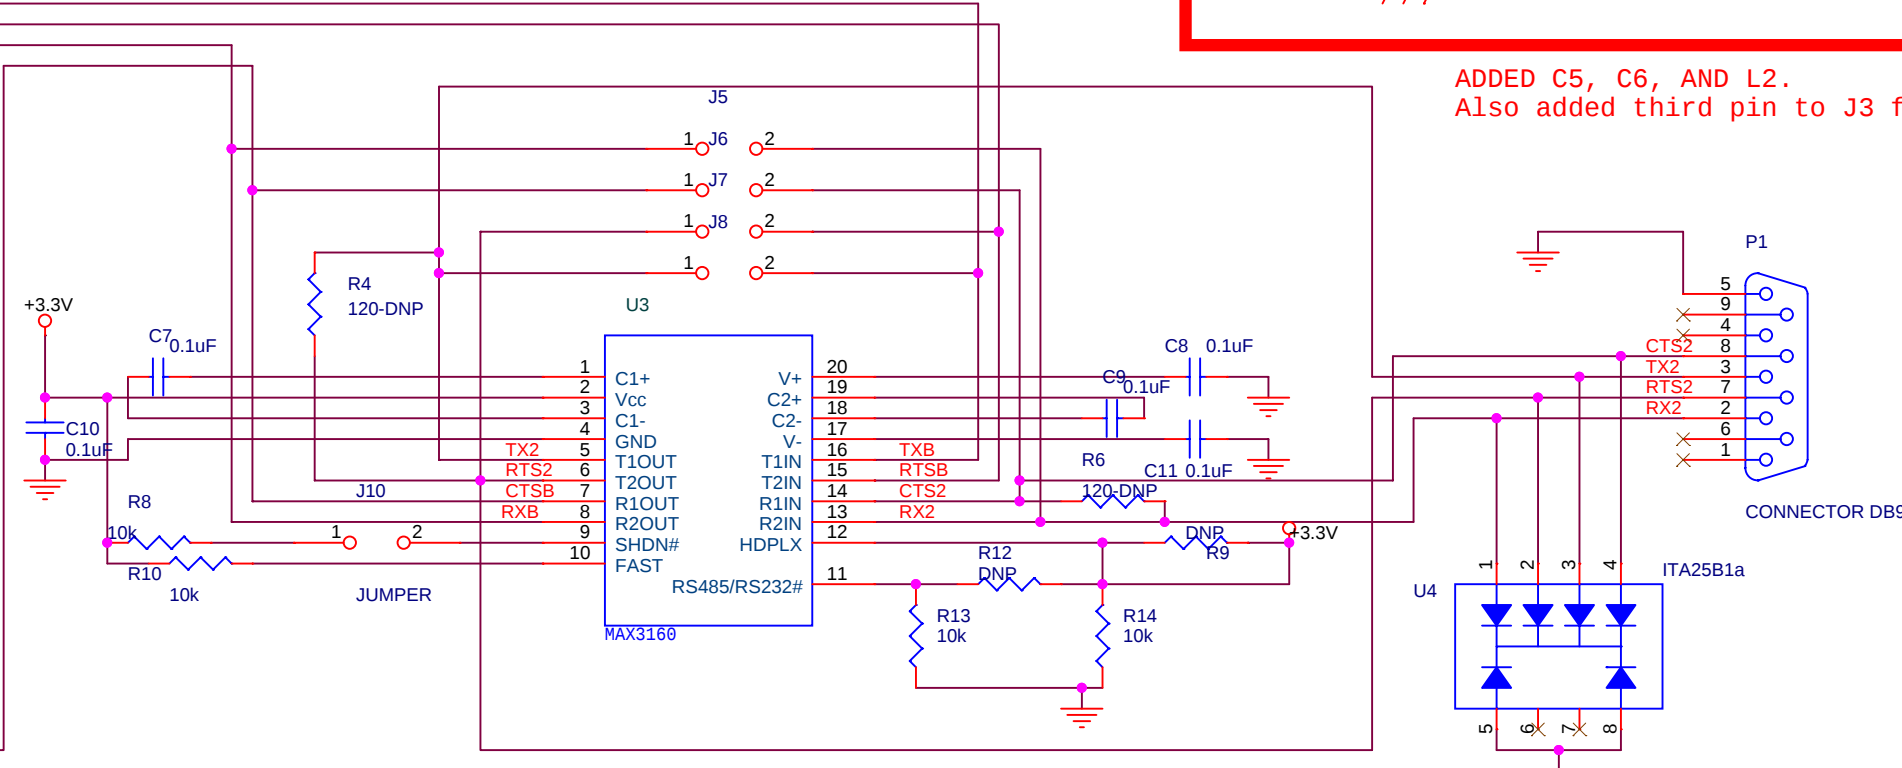
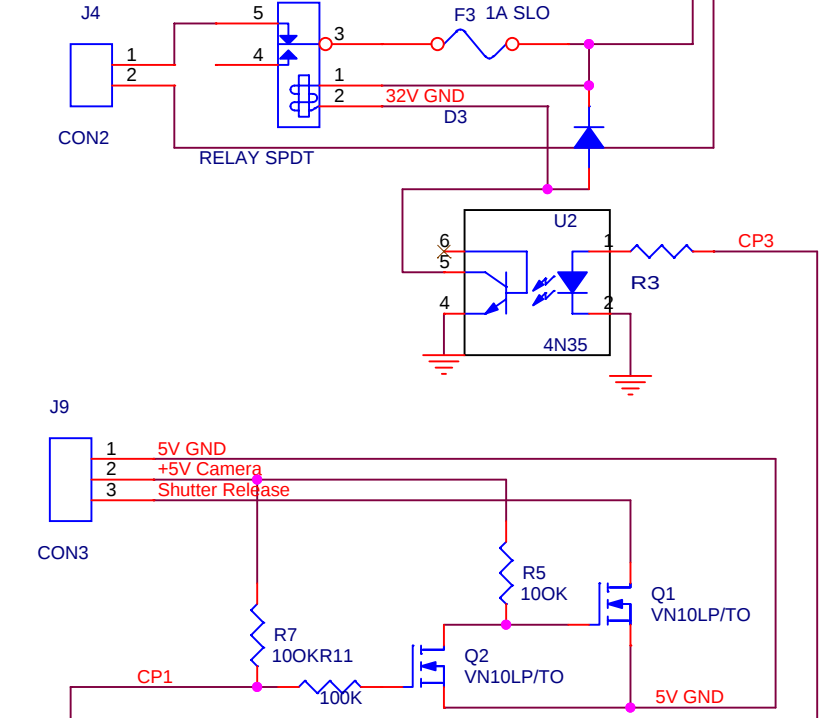
Removed 12V power supply and changed connector to attach to Vicor controller board.

ADDED C5, C6, AND L2. Also added third pin to J3 for Frame GND

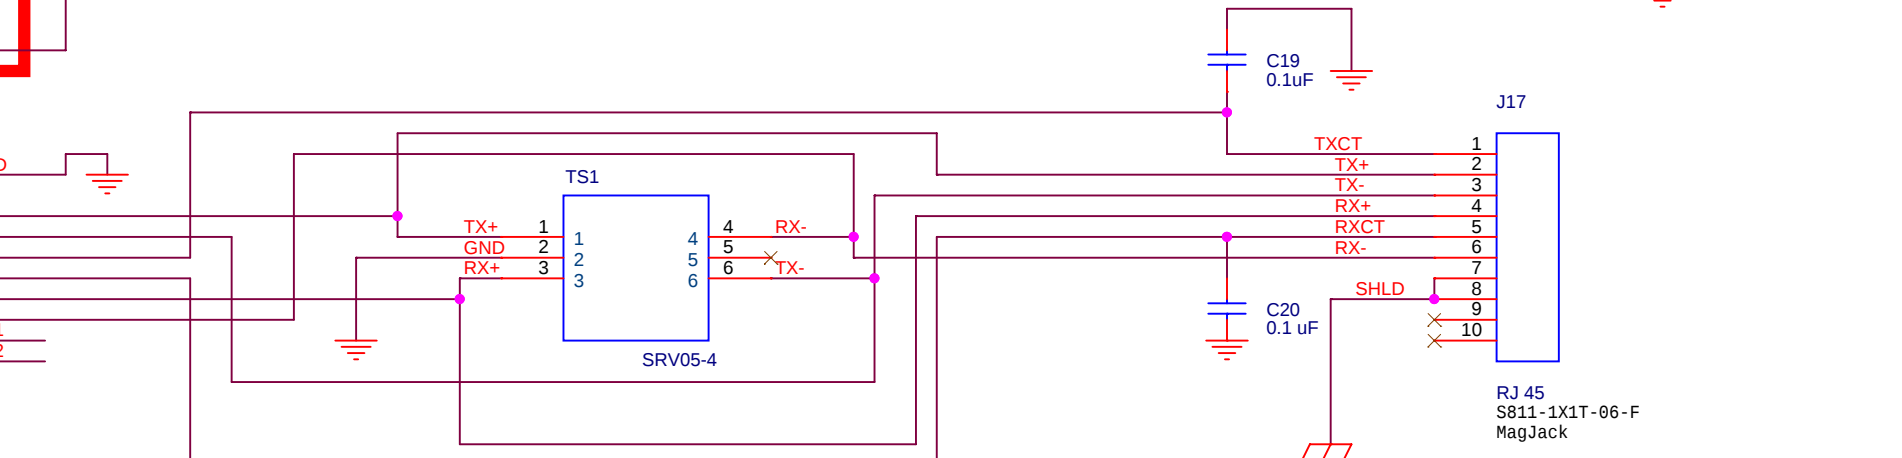
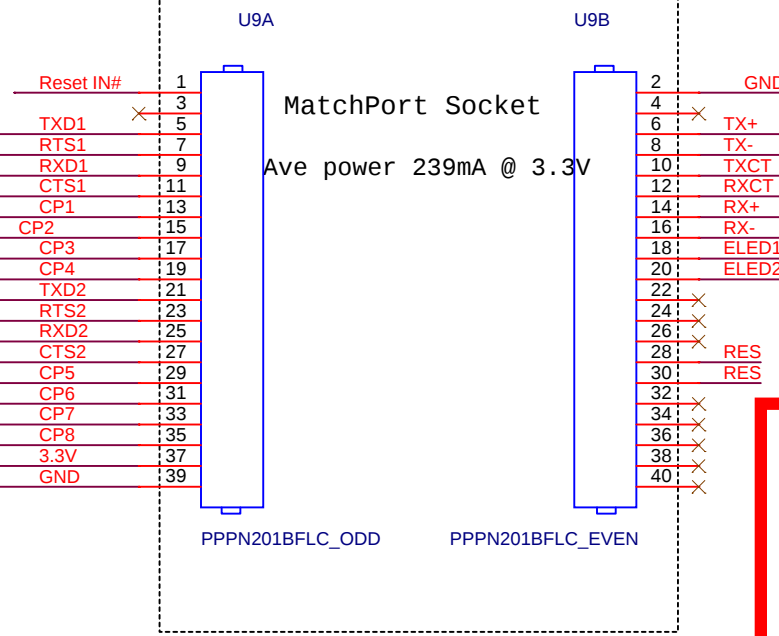
Changed connector size to 6 pins
